Consultee Comments - Urban Design

Consultee:	BNE – Urban Design
Reference Number:	23/03204/OUT
Proposal:	Outline application (with all matters reserved) for the demolition of existing buildings and structures and redevelopment of the site for a new local centre (E (a-f), F1(b-f), F2(b,d)), open space and employment (office and laboratory) floorspace (E(g)(i)(ii) to the ground floor and employment floorspace (office and laboratory) (E(g)(i)(ii) to the upper floors, along with supporting infrastructure, including pedestrian and cycle routes, vehicular access, car and cycle parking, servicing areas, landscaping and utilities. (The Development is the subject of an Environmental Impact Assessment)
Site Address:	Beehive Centre Coldham's Lane Cambridge CB1 3ET Cambridgeshire
Case Officer:	Cuma Ahmet
Responding Officer:	Sarah Chubb
Date:	09.11.23

Fig 2 – Extract from the submitted Design and Access Statement, which shows the sprawling local centre gravitating to the northwestern part of the site.

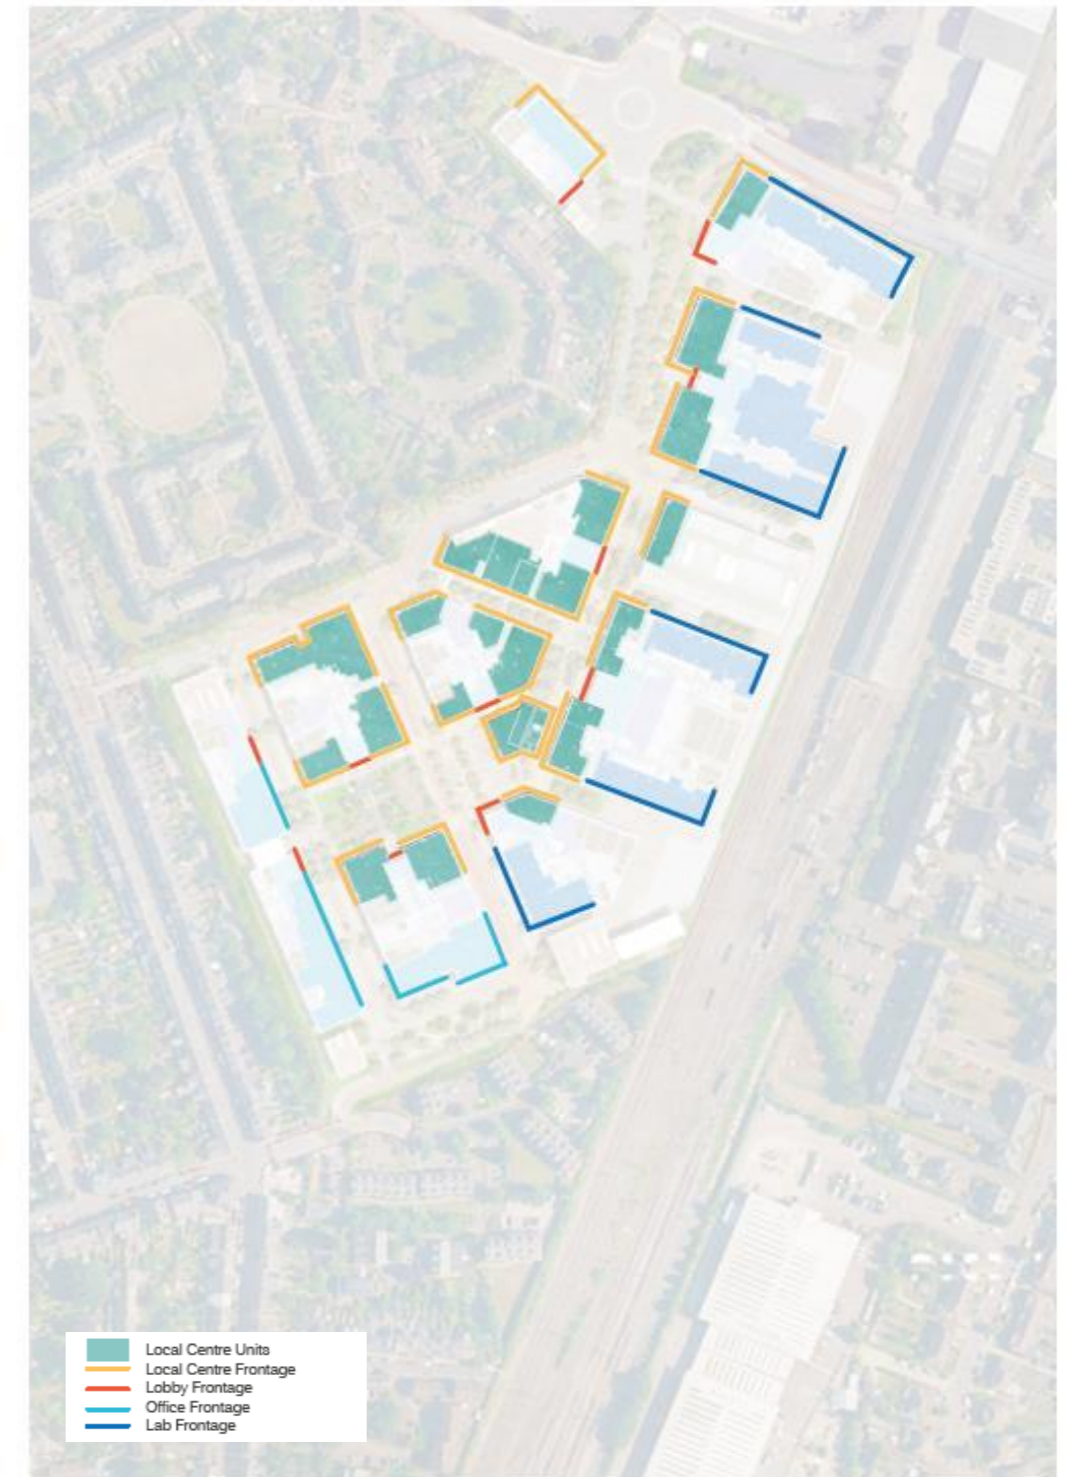
The masterplan incorrectly assigns equal weighting to these two existing pedestrian and cycle access points from York Street and Sleaford Street into the southern part of the site. This is producing a confused spatial street hierarchy, lots of hard vehicle circulation space that penetrates deep into the site, fronts and back issues along the northern western edge and an indirect main cycle link through the site. As a result, the main spine route through the site - which should be to the southwestern corner - is weak in legibility, and the footfall intensity or “heat” on this route will be watered down.

These structural movement problems is impacting upon the extent of local centre uses and frontages, which has overspilled and gravitated towards the northwestern part of the southern area of the site, further muddling the hierarchy of routes and spaces. The fundamental spatial layout proposed needs to be revisited. We have set out an alternative approach (see page 9 of comments).

We believe that a much stronger spine route through the site to the southwestern corner needs to be created; a direct and spatially legible route for both cyclists and pedestrians between Coldham’s Lane and Sleaford Street, that reflects the main desire line through the site, providing the focus for a rationalised and more consolidated “high street”, that in turn creates a more intense “hot route” of activity. Furthermore, the rationalisation of the ground floor retail space will help to absorb some of the loss of workspace that will need to occur to address scale and massing concerns.

Fig 3 (top) and Fig 4 (bottom) highlight the poor levels of visual permeability and wider legibility issues stemming from the proposed spatial layout.

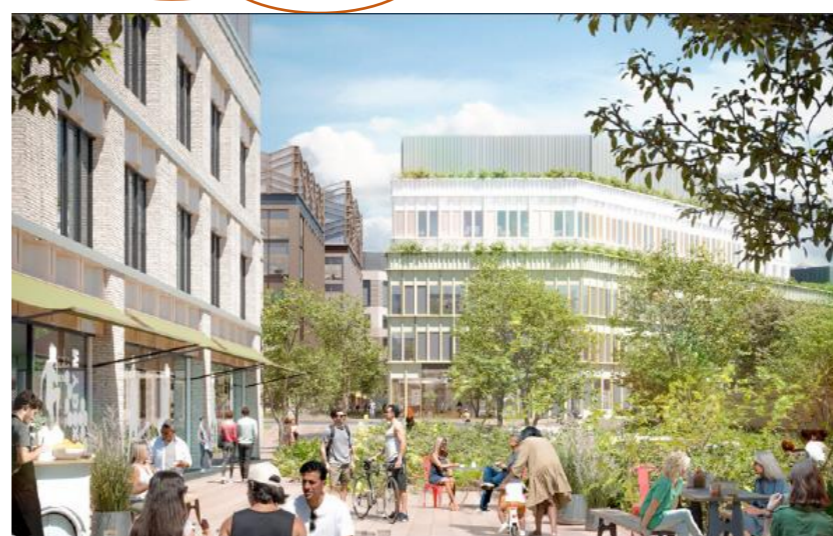
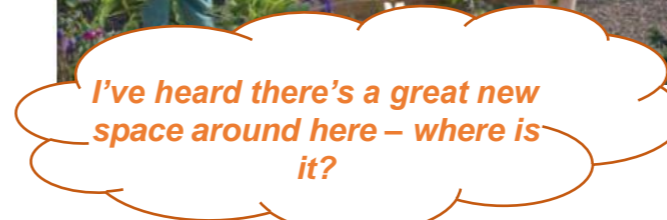
(a) Poorly defined arrival space (Abbey Grove) – The proposed key arrival green space is “leaky”, poorly defined and fails to connect to its surroundings in a coherent way, creating poor levels of continuity and enclosure both along Coldham’s Lane and into the site. Legibility is poor within the long linear open space; the CGI looking south towards Block M, illustrates how it is unclear where the main street with is. Re-imagining the roundabout as outlined in section 1, will help to create the potential for better continuity of building line along Coldham’s Lane and a tighter entrance into the site. Though our revised approach, we have introduced a defined square as a key move to address these issues, to positively anchor the arrival sequence into the site and terminate the northern end of the high street. The “mouth” between Plots M and Plot 3 has also been widened to improve visual connectivity and wider legibility.

(b) Dead-end destination space (Garden Square South) – The ambition to create a new civic scaled space is welcomed, however we are not convinced that the location of the key public space (Garden Square S) is positioned or integrated into the masterplan in the right place. As proposed it terminates the end of what is meant to be the main street but doesn’t naturally go or lead anywhere. When considered with Garden Square N, the orientation doesn’t reinforce the natural line of direction through to the Sleaford Street (SW corner) which is a key integration and access point into the surrounding community. Sunlight access will be affected by Plot H to the south. The concept of the wetland planting is interesting, but any SUDs feature needs to be part of a larger space. The current illustrative concept means that the wetland area will take up most of the space, limiting activity to the edges. A city scaled destination space, should be the instrument for urban transformation, working as an integration tool to create a sense of continuity with the wider context. It would be better to amalgamate the spatial area of Garden Square South and Vera Gardens, to create one larger destination “park” space which would reduce competition for use and accommodate strategic tree planting.

(c) Southern entrance space (Vera’s Garden) – The southern open space feels confused and like a back door entrance to the proposal. The wide and shallow space is flanked by the existing wall and cycle stores; the southern façade of office Plot H does not balance this shallow space. Vehicle circulation pulling into the SW corner running in front of Plot H, further compromises this already constrained space. The CGI image on page 48 of the DAS offers little comfort; which demonstrates how the space fails to contribute to a wider legible structure. The proposed allotment use feels like an afterthought to try to give this space meaning.

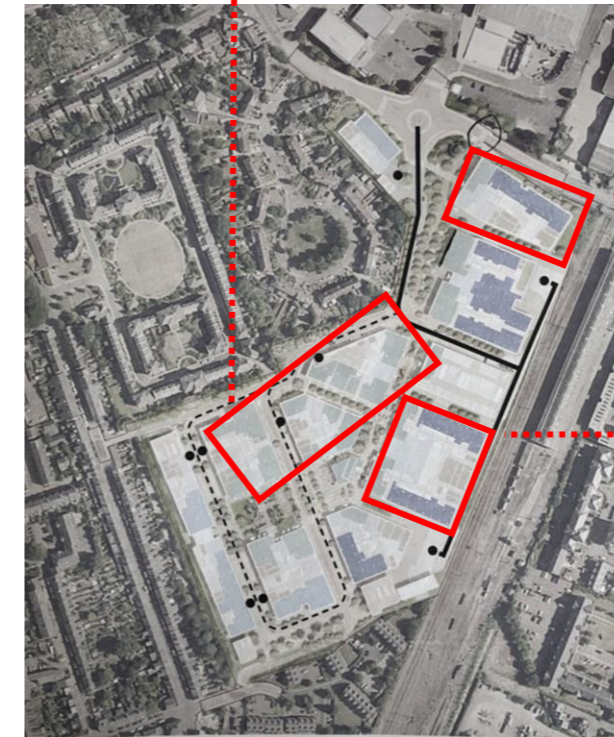
a) Longer view impact – The proposed scale, mass and bulk will result in an unacceptable harmful visual impact on the skyline of the City and the historic core, completely changing how we view and understand the City from longer distance policy 60 viewpoints. This impact is most obvious in the verified views from Worts Causeway, Little Trees Hill, Red Meadow Hill and Castle Mound. The change is very prominent from Castle Mound (view 01) which due to the large floorplates and massing envelopes being established in the parameter plans, the proposal will appear as a dominant, discordant and bulky intrusion on the skyline; competing with the horizon and the fine, layered grain of the City fabric that is formed by the interplay of mature tree cover and buildings. Plots H, K, L, M, G and F coalesce into a monolithic, bulky cluster that form uncomfortable, overly horizontal and jarring additions to this prominent view. The proportions of Plot C rise above the prevailing townscape in a boxy and ungainly manner. The illustrative scheme visualisations demonstrate to us, that the imposing visual impact cannot be mitigated by variations in elevational design or roofscape that the design code seeks to control. A reduction in scale is required to these Plots to manage the bulky volumes generated by the large floorplates, and then a more targeted and contextual approach to taller additions is required that seeks to create more slender proportions on the skyline.

b) Localised views – From an urban design perspective, the railway edge could in principle potentially accommodate an increased sense of scale as per other railway corridor sites, however as proposed, we object to the heights and massing being sought through the outline application. The verified view from Coldham's Common (view 03) illustrates how the bulk of the proposals feel incongruous and foreign within the view. Transitions between volumes appear awkward. The scale and bulk of Plot F is particularly monolithic and will loom over its immediate surroundings and will dominate views from this part of the common. A reduced datum height of around 20m for the railway plots would as a start help to mitigate this harm. The prominence of Plot F is unjustified and confused in placemaking terms, which currently has a weak role in the masterplan. Plot C's ungainly proportions and horizontal emphasis only serves to exacerbate the stark contrast in bulk with the layered foreground fabric consisting of domestic rhythms and mature trees punctuating the articulated roofscapes. There is the opportunity for a marker building to announce the entrance into the scheme, but this needs to read as a discrete element on the skyline with more slender, vertical proportions, working hard to find a more domestic silhouette.

The proposed scale of the plots that line the railway are also problematic from corner of Sleaford Street (view 04). From this view, the massing volumes of Plots H and G coalesce above the trees striking an overly horizontal emphasis in a finger grain context of the conservation area, where vertical proportions and rhythms predominate and roofscape notches form a key characteristic.

The deep footprint of Plot C extruded at a uniform height creates a bulky volume with a prominent long horizontal line.

The large footprint of Plot F at the proposed height creates a boxy and horizontal silhouette that dominates and looms over the finer grain foreground.

Fig 6 – Illustrative masterplan Proposal from 34 Silverwood Close

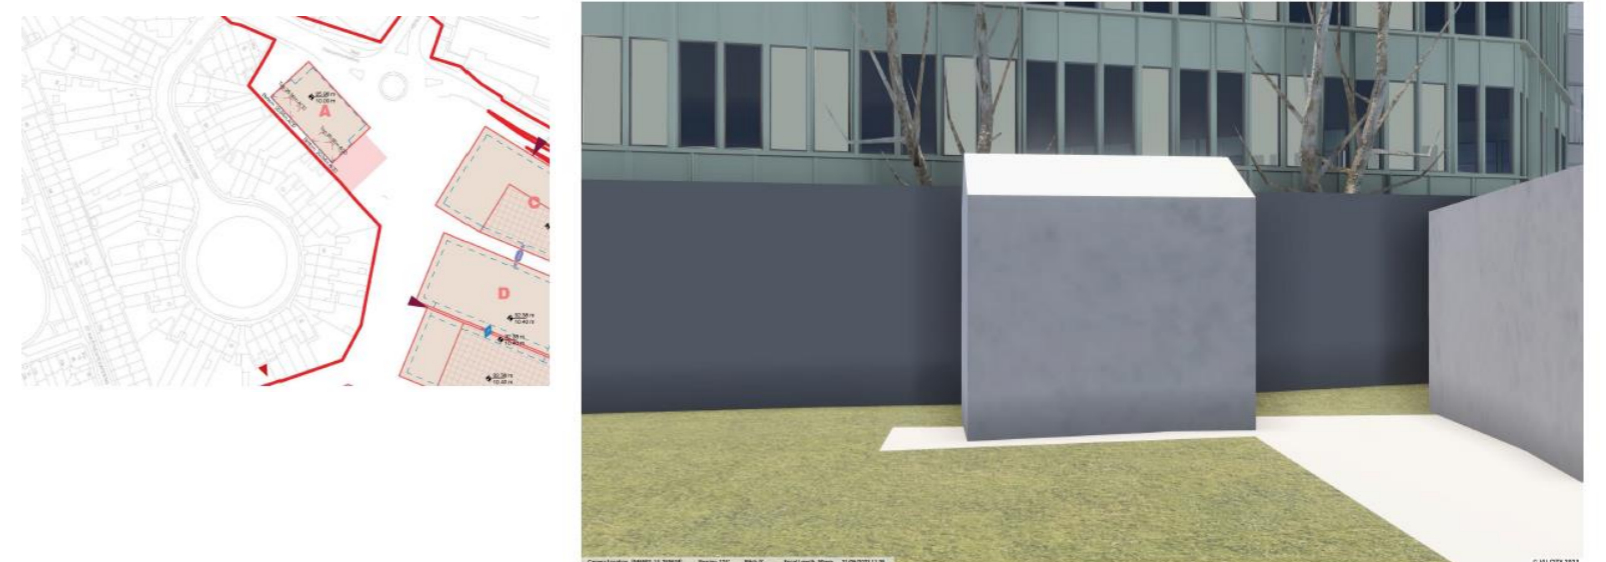
The proposed upper limit of 20.2m proposed for Plots I and J is of concern, which will create an unacceptable overbearing impact when viewed from the rear gardens of York Street. Therefore, to create a more comfortable relationship the upper limit of these blocks should be fixed at 15.1m, and the inclined slope parameter extended across the entire length of these buildings. The existing, mature green edge along Rope Walk, currently provides an effective screen between properties and the existing beehive buildings and will be important to mitigating the impacts of a change in scale and mass around this part of the site. It is unclear whether the proximity of the proposed plots has been determined with the objective to safeguard the health and therefore the current screening effectiveness of the existing vegetation in addition to any of the assumed works. Further clarification is needed.

The proximity of Plot A which sits tight to the rear boundary of Silverwood Close and the length of the northern edge of Plot M is of concern, which according to our modelling work will create an overbearing impact. As indicated on our alternative approach, a better relationship could be formed by pulling Plot A away from this boundary and shortening the length of the northern boundary of Plot M so that it reflects the length of the terraces found in Silverwood Close.

Fig 8 - Alternative layout and massing strategy

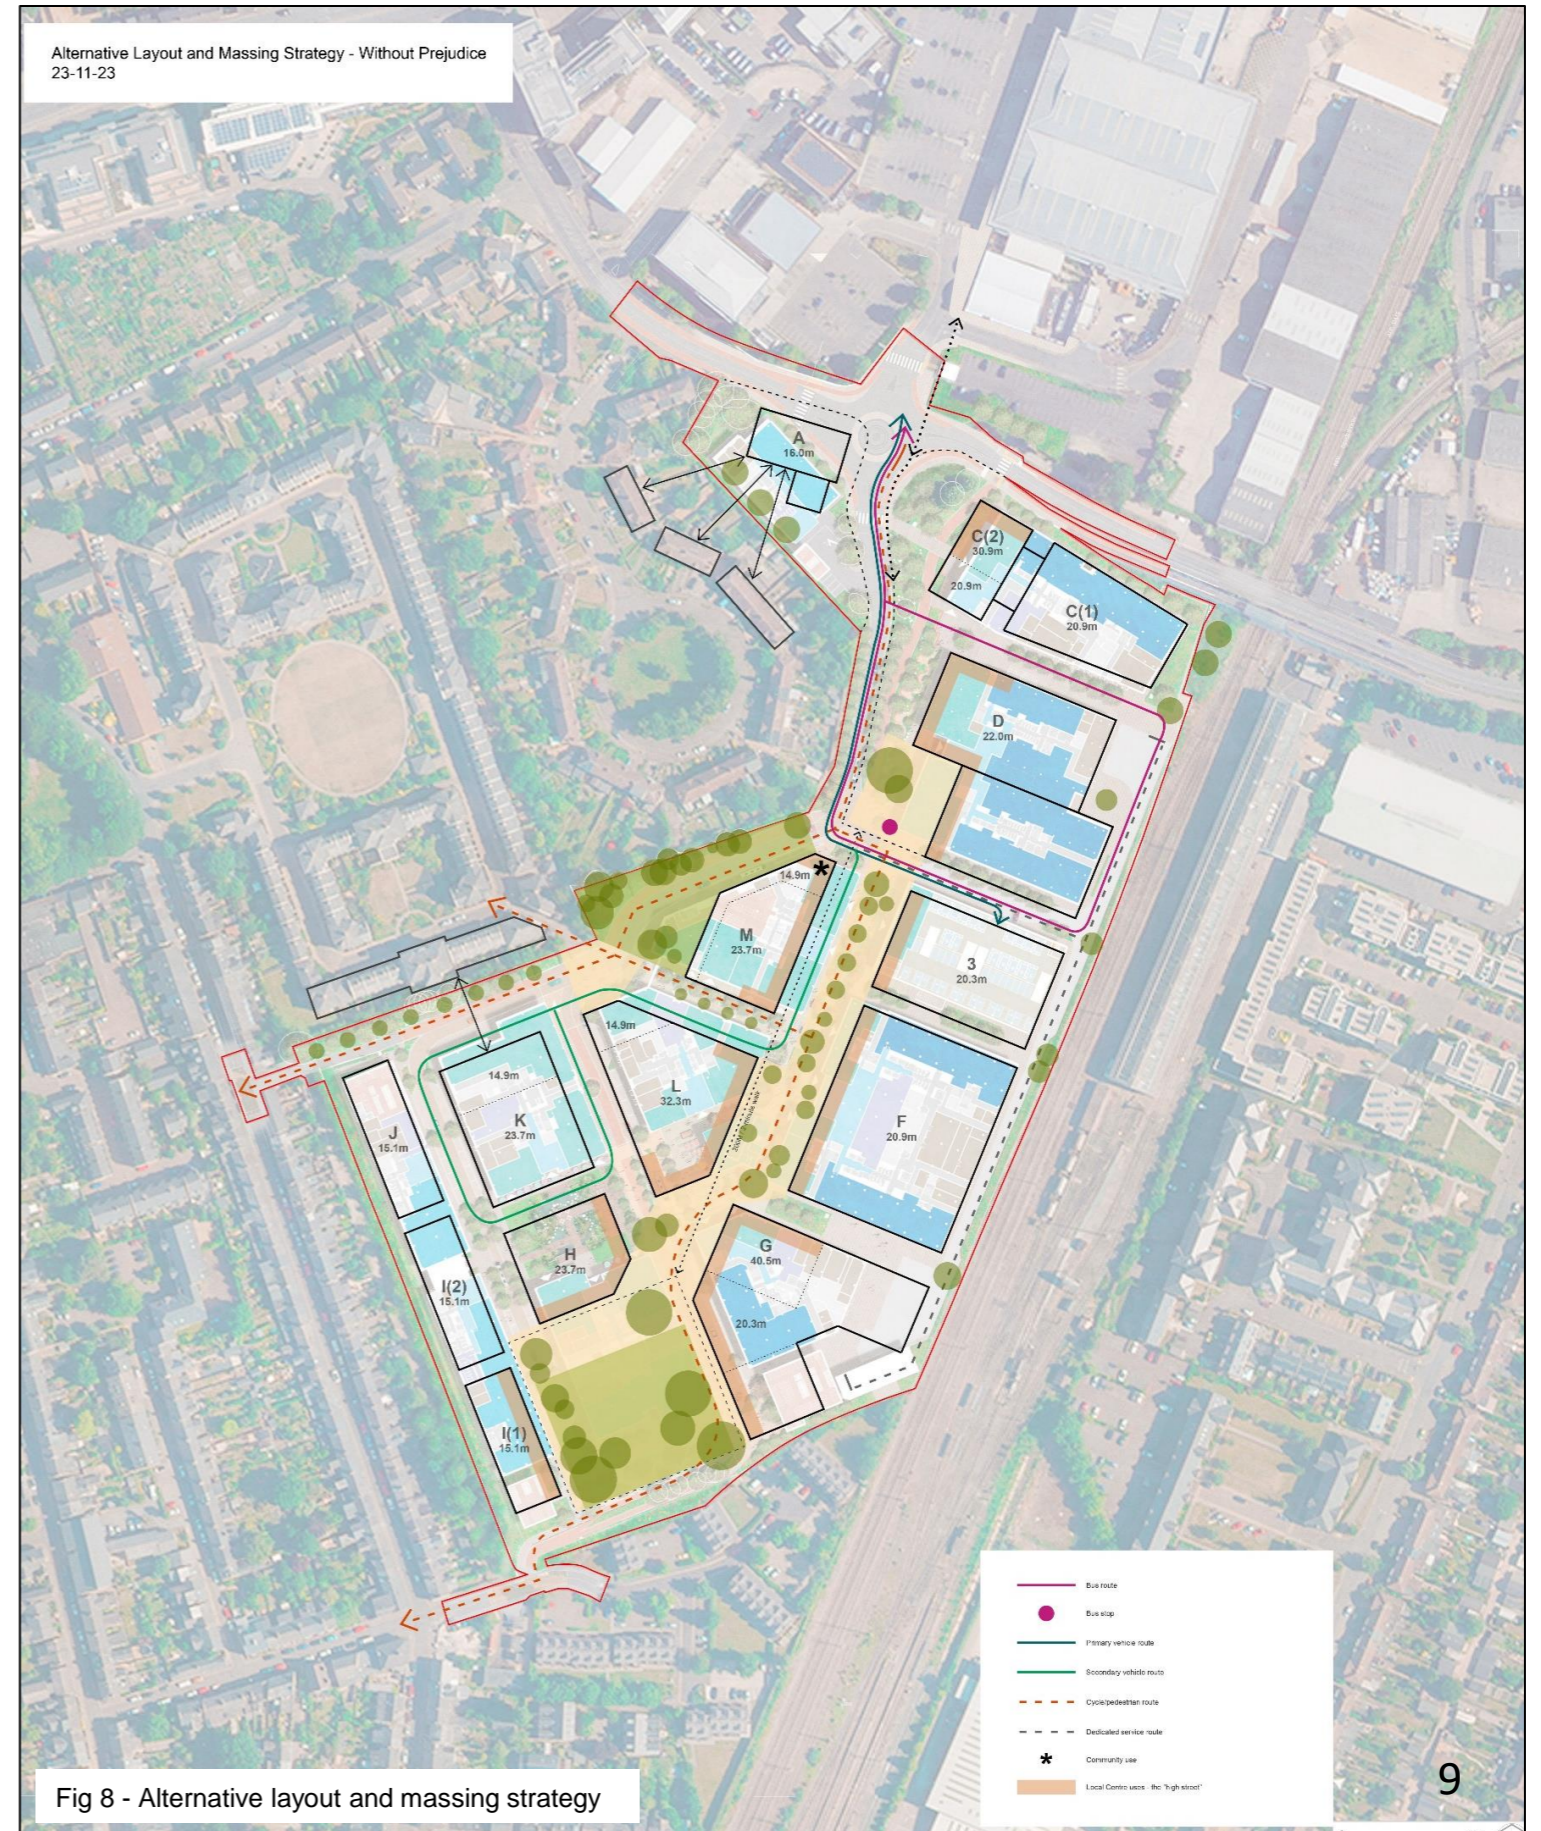
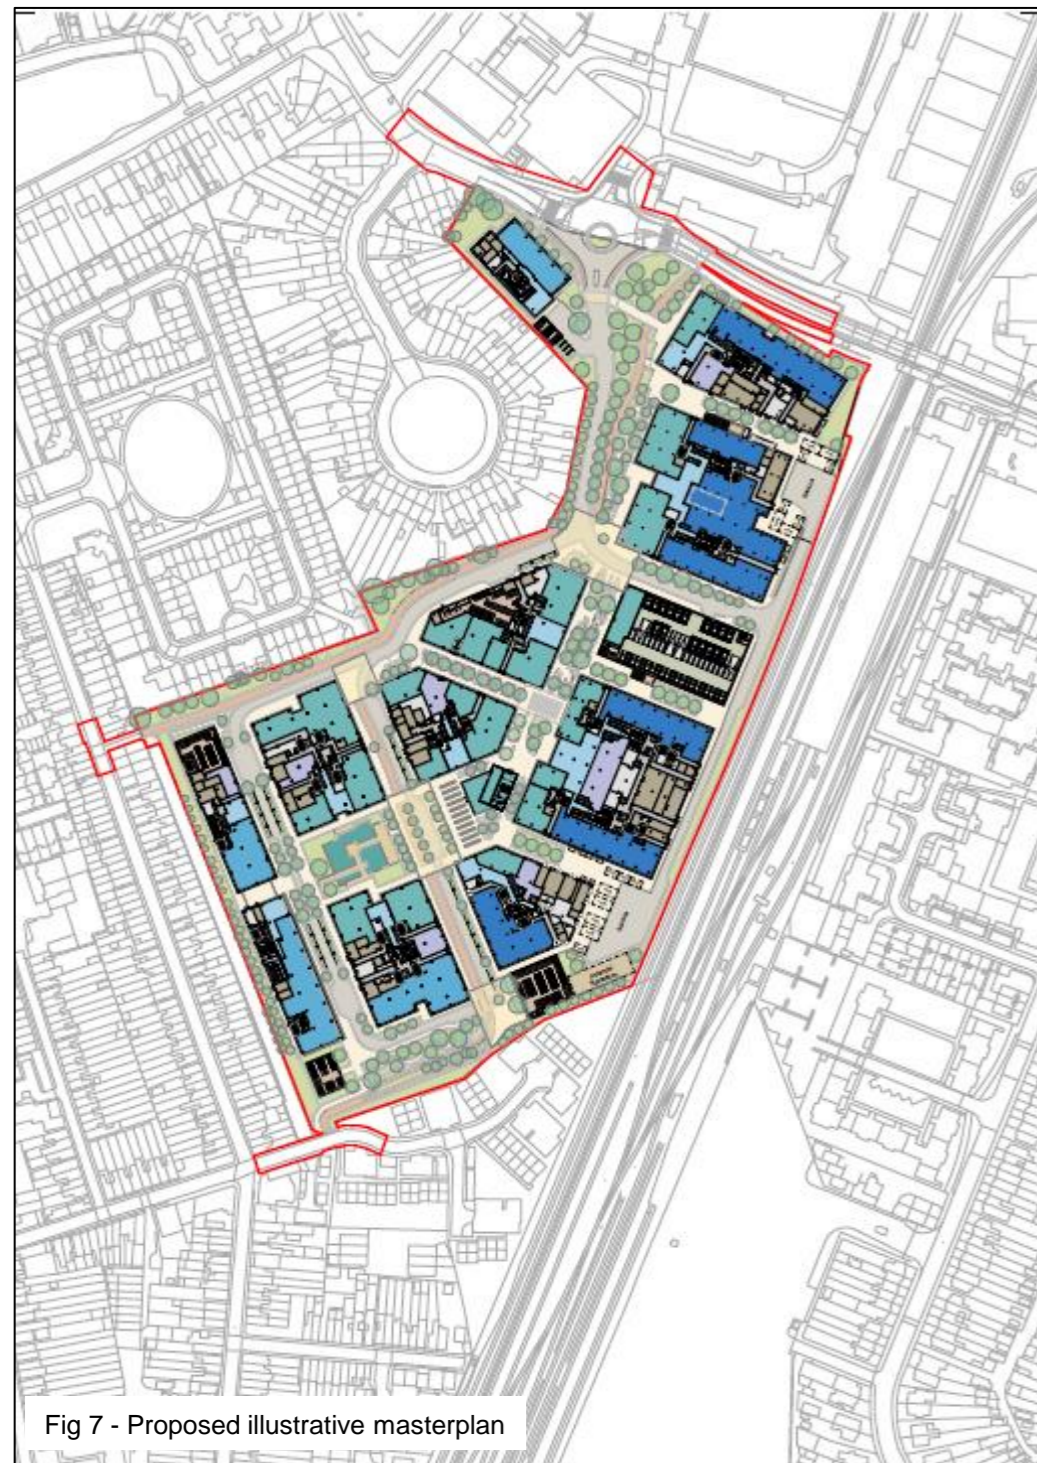
The following pages set out an alternative approach for reorganising and re-imagining the site in a way to respond positively to our concerns, other technical consultees and the community. The suggested layout and massing strategies are given without prejudice, providing alternative concepts and approaches for further design development and testing through verified views, including additional viewpoints from the rear gardens of existing residential properties.
